WATER QUALITY MEMORANDUM

Utah Coal Regulatory Program

RE: Third Quarter 2018 Water Monitoring, Wolverine Fuels, Fossil Rock Mine, C/015/0009, Task ID #5791

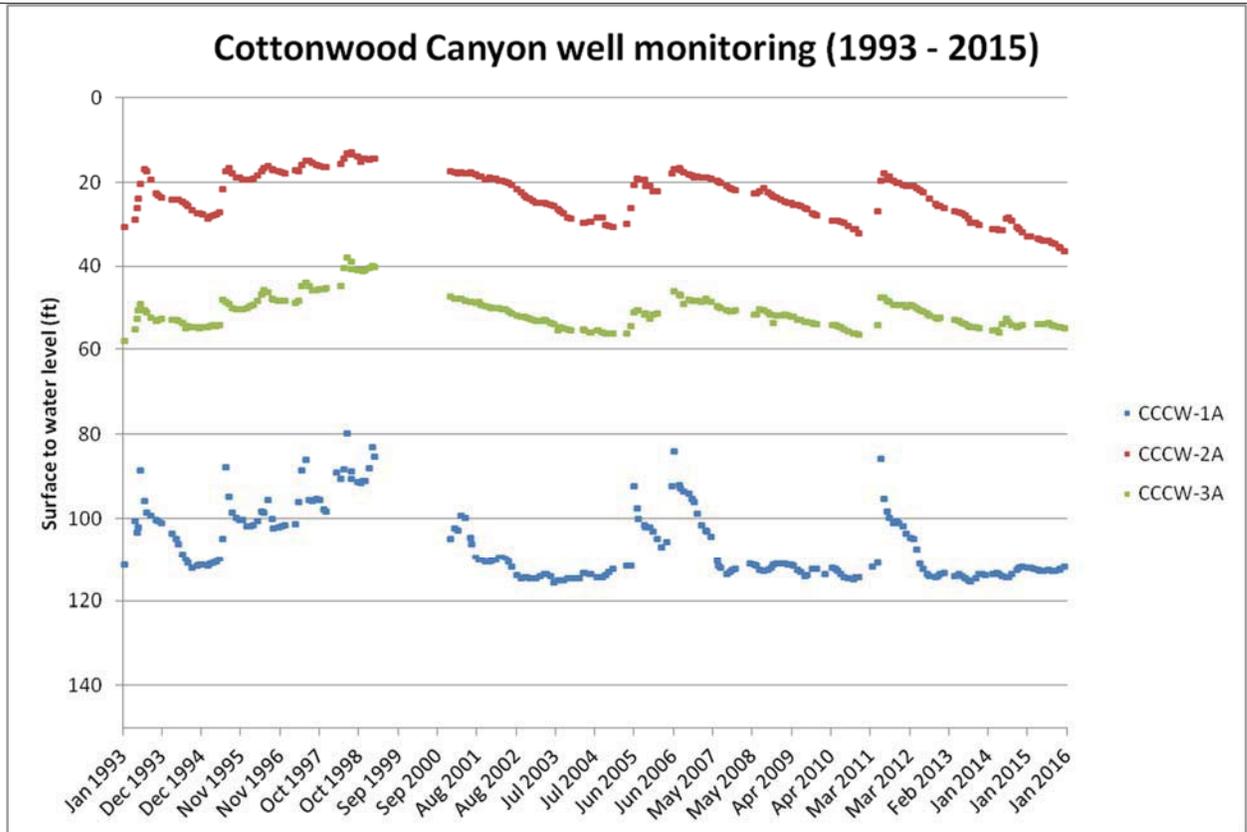
Well TM-1B is monitored for water level monthly and for operational parameters quarterly. Since July 2004, the water level in TM-3 has been reported as potentiometric head above the well casing by measuring the pressure on top of the sealed wellhead with a gauge. CCCW – 1A, CCCW – 1S, CCCW

– 2A, CCCW – 3A, CCCW – 3U, CCCW – 3L are monitored for water level only (Figure 3 shows alluvial wells).

**APPX incorrectly subtracted the depth to water measurements from the elevation of the casing to calculate the Water Level values. This means the ‘Depth’ water level measurement is correct, but WL or water level elevation is incorrect.
